**Jane Farwell - SYRWCD and SYRWCD, I.D. No. 1, Joint Comments on Cachuma 2nd RDEIR**

Re: Comments on the Second Revised Draft Environmental Impact Report Prepared in Connection with Consideration of Modifications to United States Bureau of Reclamation's Water Right Permits 11308 and 11310 (Applications 11331 and 11332) to Protect Public Trust Values and Downstream Water Rights on the Santa Ynez River below Bradbury Dam (Cachuma Reservoir), dated April 2011 (SCH#1999051051)

**TECHNICAL COMMENTS**

This document is appended to and incorporated by reference in Comments on the Second Revised Draft Environmental Impact Report prepared in connection with Consideration of Modifications to United States Bureau of Reclamation's Water Rights Permits 11308 and 11310 (Applications 11331 and 11332) to Protect Public Trust Values and Downstream Water Rights on the Santa Ynez River below Bradbury Dam (Cachuma Reservoir), dated April 2011 (SCH#1999051051).

FIGURE 24

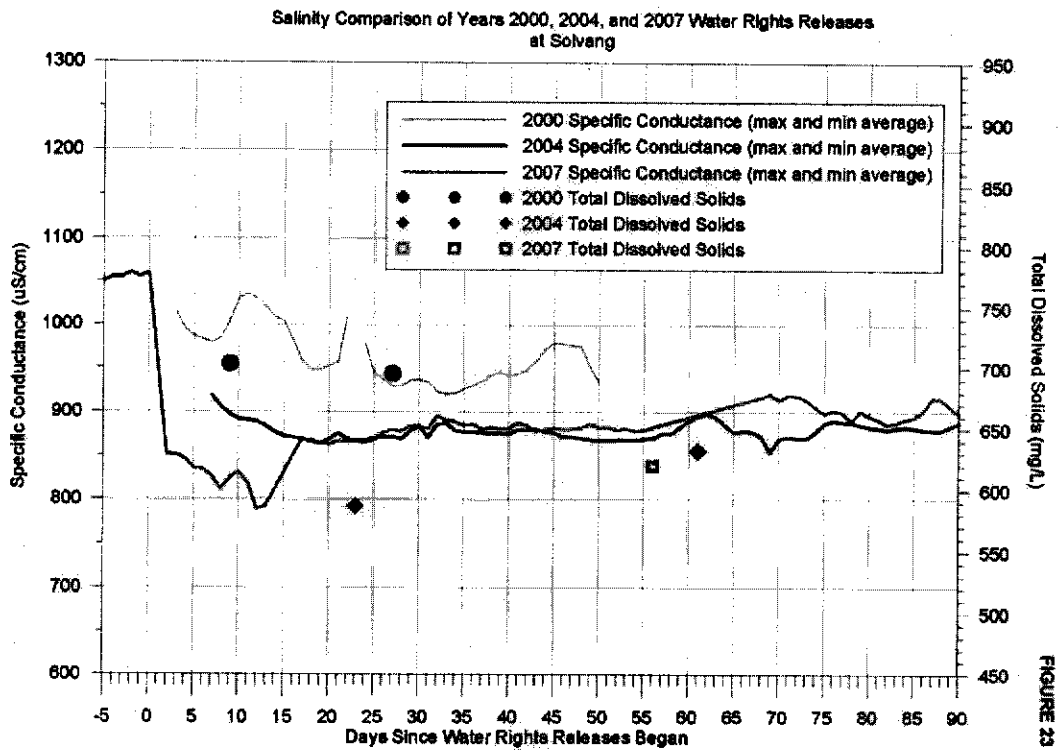
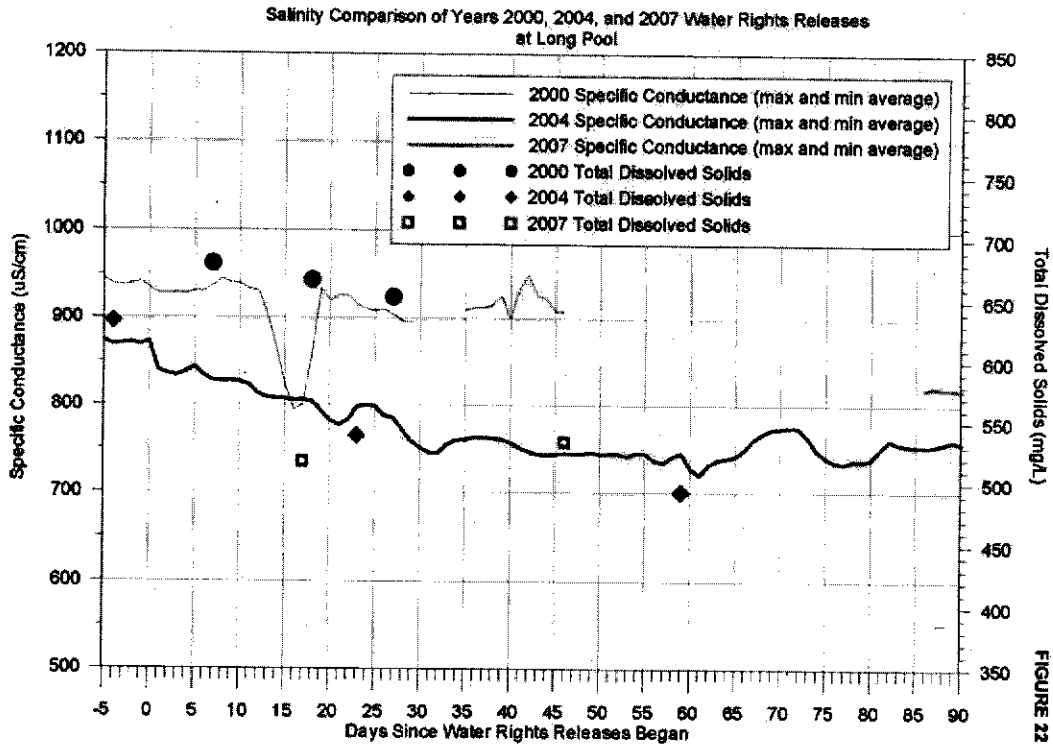
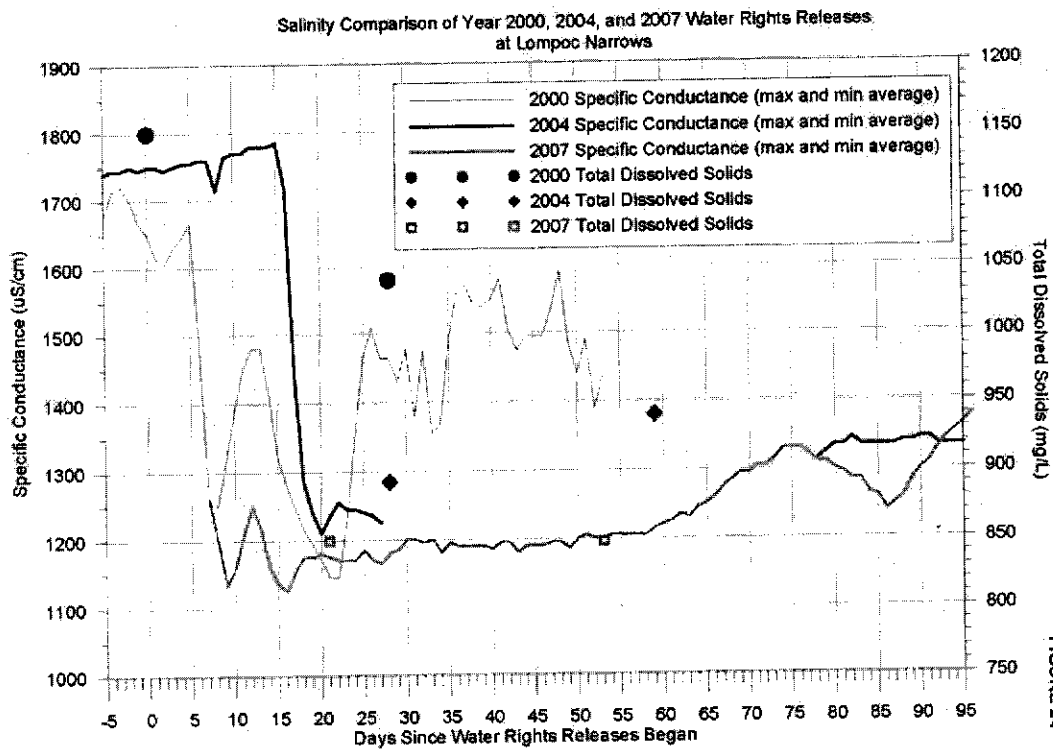
1. Page 11, para 5, lines 7-14: Delete. Trends in salinity cannot be estimated from sample data at Solvang and the Narrows because samples are collected at different flow rates. Ideally, continuous EC data should be used to determine trends in salinity. Suggest adding the following paragraphs:

"Continuous EC for salinity was measured during water rights releases in 2000, 2004 and 2007. In 2000, very little SWP water was mixed in with the releases but SWP water was mixed continuously during the 2004 and 2007 releases. These years have available specific conductance data as well as water quality samples. Figures 22 through 24 from the report "Water Quality in the Lower Santa Ynez River 2007 Water Rights Releases" (Stetson, 2008) show salinity data at the USGS Long Pool, Solvang and Lompoc Narrows gages, respectively. The effect of SWP water is clearly noticeable at the Long Pool gage when SWP was mixed in water rights releases for about five days in year 2000. During this short period of SWP mixing, salinity dropped to the 2004 and 2007 levels. Overall, the 2004 and 2007 water rights releases were about 110 to 130 mg/L lower in total dissolved solids concentration than the year 2000 water rights releases at the Long Pool gage. The reduction in salinity due to SWP water mixing would result in a reduction of about 1,700 to 2,400 tons of salt loading in the lower Santa Ynez River for the total amount of 11,600 acre-feet of water rights releases in 2007."

"Other locations downstream of Bradbury Dam also show improvements in water quality in the 2004 and 2007 water rights releases compared to year 2000. Figures 23 and 24 show that the 2004 and 2007 water rights releases were about 100 to 150 mg/L lower in total dissolved solids concentration than the 2000 water rights releases at both Solvang and the Lompoc Narrows. Figure 24 shows that the 2007 water rights releases have the lowest salinity at the Lompoc Narrows compared to the releases in 2000 and 2004."
